HISTORIC AND DESIGN REVIEW COMMISSION

July 20, 2022

HDRC CASE NO: 2022-339
ADDRESS: 516 NOLAN ST
LEGAL DESCRIPTION: NCB 560 BLK 18 LOT 4
ZONING: R-6, H
CITY COUNCIL DIST.: 2
HIST. DIST. NAME: Dignowity Hill
APPLICANT: Juan Sanchez/1715 Sandringham
OWNER: Deborah Roerig/412 RIVER RD STE 101
TYPE OF WORK: Addition, window replacement
APPLICATION RECEIVED: June 7, 2022
60-DAY REVIEW: Not applicable due to City Council Emergency Orders
CASE MANAGER: Jessica Anderson

2 Roof Deck plan
Scale: 3/32" = 1'-0"

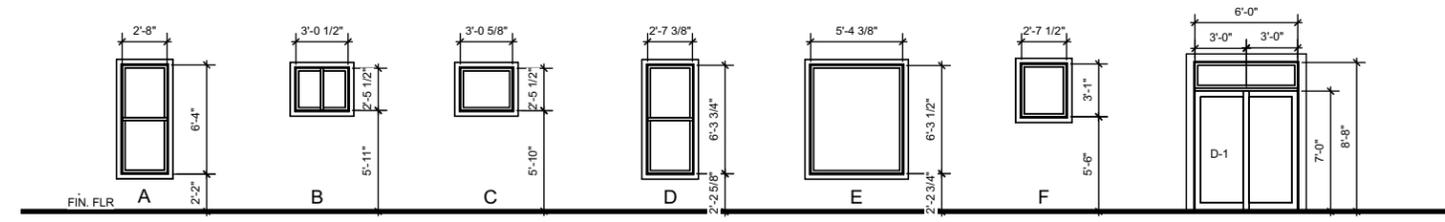
- d. ADDITION: ROOF: The applicant proposes a roof form that has a composition shingle gabled roof and a flat roof deck. Guideline 1.A.iii for Additions stipulates that residential additions should utilize a similar roof pitch, form, overhang, and orientation as the historic structure. Staff finds that the flat roof form might be appropriate for the structure if it was not visible from the public right-of-way and if the addition did not modify the existing roof form. Staff finds that the applicant should propose a roof form that is similar to the historic structure or appropriate for the style and that the applicant should avoid modifying the original roof form.

- h. **ADDITION: ARCHITECTURA DETAILS: RAILING:** The applicant proposes metal cable fencing for the ground-floor deck as well as the roof deck. Guideline 4.A.ii for Additions states that additions should incorporate architectural details that are in keeping with the architectural style of the original structure. Details should be simple in design and compliment the character of the original structure. Staff finds the proposed cable railing does not conform to guidelines.

- i. That the applicant propose a roof form that is similar to the historic structure or appropriate for the style.
- ii. That where windows on the rear addition are 60” in height, they be 30” wide to match conditions on the existing rear addition.
- iii. That the applicant propose wood siding that matches the 1909 phase of the house in profile, dimensions, and treatment (paint) and utilize a trim piece to differentiate new and old.
- iv. That the applicant propose a style of railing keeping with the architectural style of the original structure, such as a wood railing similar to what is found on the front porch.

- i. That the applicant propose a style of railing keeping with the architectural style of the original structure, such as a wood railing similar to what is found on the front porch.

1 Floor Plan
Scale: 1/8" = 1'-0"

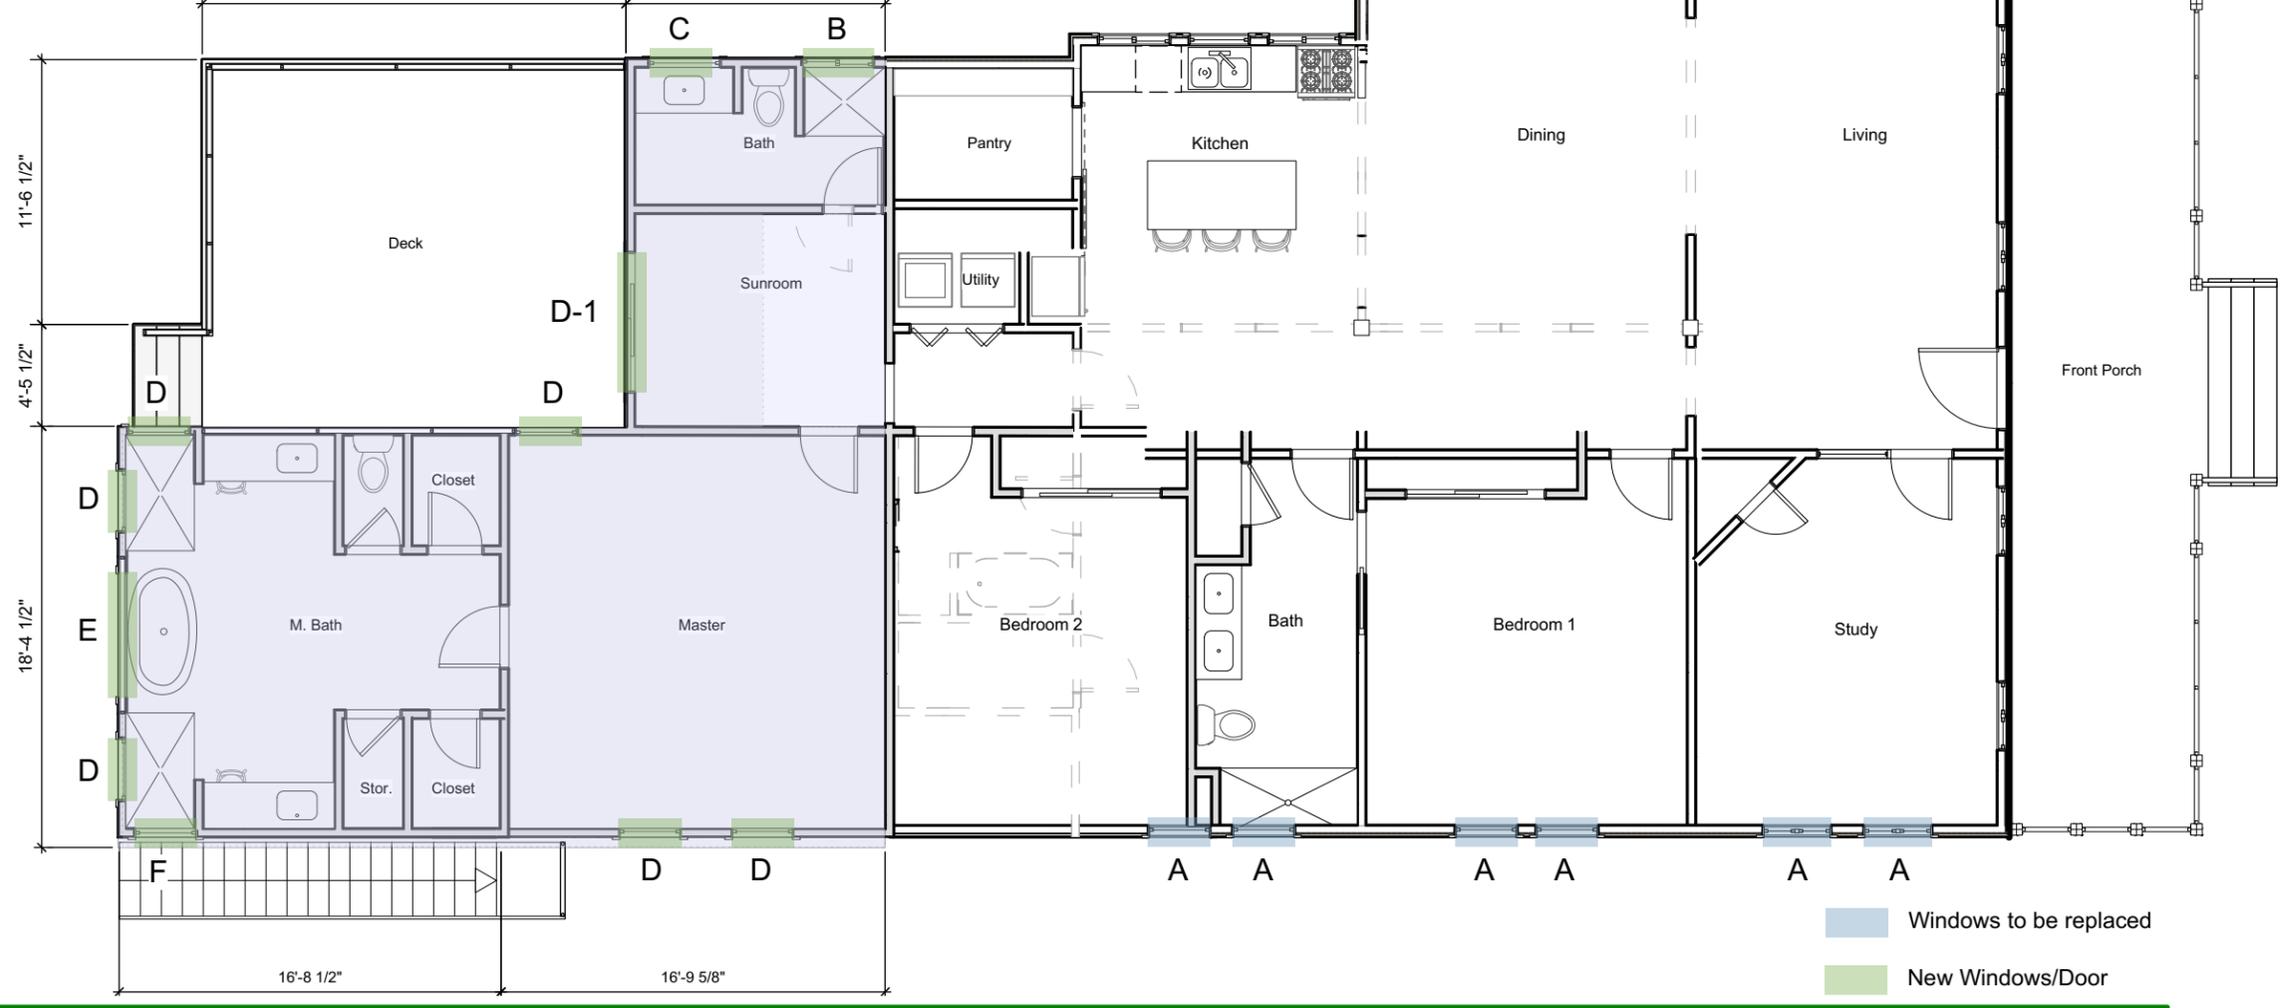
- b. ADDITION: LOT COVERAGE: The applicant proposes to construct a one-story 810-square-foot rear addition with roof deck and a 310-square-foot rear deck. The total square footage of the existing primary structure is 2,218 square feet on a lot measuring 11,532 square feet. According to the Historic Design Guidelines, the building footprint for new construction should be limited to no more than 50 percent of the total lot area, unless adjacent historic buildings establish a precedent with a greater building to lot ratio. A building footprint should respond to the size of the lot. The applicant proposes a total square footage of 3,028 square feet, for approximately 26% lot coverage. With the 310-square-foot rear deck, lot coverage increases to 3,338 square feet, for approximately 29% lot coverage. Staff finds the proposal consistent with the guidelines.

- c. ADDITION: MASSING AND FOOTPRINT: The applicant proposes to construct a one-story 810-square-foot rear addition with roof deck and a 310-square-foot rear deck. The existing primary structure is 2,218 square feet. Guideline 1.B.i for Additions stipulates that residential additions should be designed to be subordinate to the principal façade of the original structure in terms of scale and mass. Guideline 2.B.iv for Additions states that the building footprint should respond to the size of the lot. An appropriate yard to building ratio should be maintained for consistency within historic districts. Residential additions should not be so large as to double the existing building footprint, regardless of lot size. Staff finds the proposed addition consistent with the Guidelines.

- e. ADDITION: MATERIALS: NEW WINDOWS: The applicant proposes to include two 24"x60" wood windows, one 24"x36" wood window, and three ganged 30"x60" windows on the north elevation of the proposed addition and one 30"x60" window on the west elevation to match existing wood windows on that elevation. The applicant shared with staff that he plans to find salvaged wood windows for the project. Guideline 3.B.i for Additions states that imitation or synthetic materials, such as vinyl siding, brick or simulated stone veneer, plastic, or other materials not compatible with the architectural style and materials of the original structure, may not be used. Wood or aluminum-clad wood windows are recommended and should feature an inset of two (2) inches within facades and should feature profiles that are found historically within the immediate vicinity. An alternative window material may be proposed, provided that the window features meeting rails that are no taller than 1.25" and stiles no wider than 2.25". White manufacturer's color is not allowed, and color selection must be presented to staff. There should be a minimum of two inches in depth between the front face of the window trim and the front face of the top window sash. This must be accomplished by recessing the window sufficiently within the opening or with the installation of additional window trim to add thickness. Window trim must feature traditional dimensions and an architecturally appropriate sill detail. Window track components must be painted to match the window trim or be concealed by a wood window screen set within the opening. Staff finds the use of salvaged wood windows appropriate, but recommends windows that are 60" tall all be 30" wide to match conditions on the existing addition. Staff finds the 24"x36" wood window on the north elevation generally appropriate. All windows, regardless of size, should be one-over-one and wood sash with one-over-one wood screens.

- j. **WINDOW REPLACEMENT:** The applicant requests approval to replace two wood casement windows and four one-over-one wood windows with aluminum-frame windows. Standard Specifications for Original Wood Window Replacement state that when individual elements such as sills, muntins, rails, sashes, or glazing has deteriorated, every effort should be made to repair or reconstruct that individual element prior to consideration of wholesale replacement. Based on photos provided by the applicant, the windows appear in repairable condition. Staff finds the request to replace the windows does not conform to guidelines. Should the HDRC feel compelled to approve replacement of original wood windows, the applicant proposes an aluminum-sash window product. Standard Stipulations for Original Wood Window Replacement state that if full window replacement is approved, the new windows must feature primed and painted wood exterior finish. Clad, composition, or non-wood options are not allowed unless explicitly approved by the commission. Staff finds the aluminum-sash windows proposed by the applicant do not conform to these stipulations.

6 Rear Elevation
Scale: 1/4" = 1'-0"

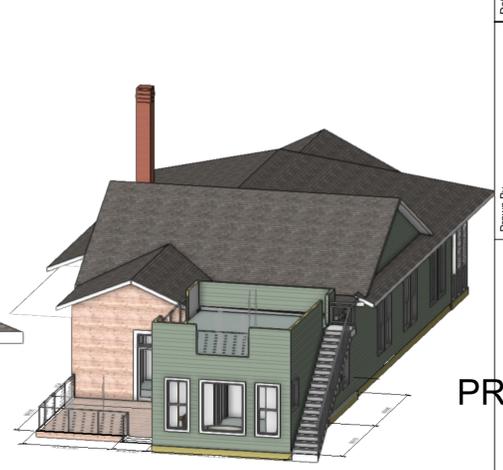
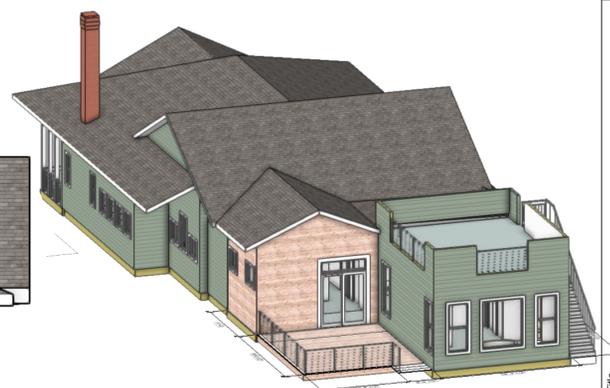
- f. ADDITION: DOOR: The applicant proposes moving a door from the east side of the existing rear addition to the east side of the proposed addition. Staff finds this generally appropriate, but finds the style of the existing door inappropriate. The new door should match the Folk Victorian house in style, such as half-lite wood door, commonly found on secondary entrances of Folk Victorian homes.

- g. ADDITION: ARCHITECTURAL DETAILS: SIDING: The applicant proposes to install painted and stained wood siding on the proposed addition to match the existing siding. Guideline 4.A.ii for Additions states that additions should incorporate architectural details that are in keeping with the architectural style of the original structure. Details should be simple in design and compliment the character of the original structure. Architectural details that are more ornate or elaborate than those found on the original structure should not be used to avoid

drawing undue attention to the addition. Staff finds that the stained wood siding found on part of the proposed addition does not conform to guidelines. Staff finds all siding should match that on the 1909 phase of the house in profile, dimensions, and treatment (paint).
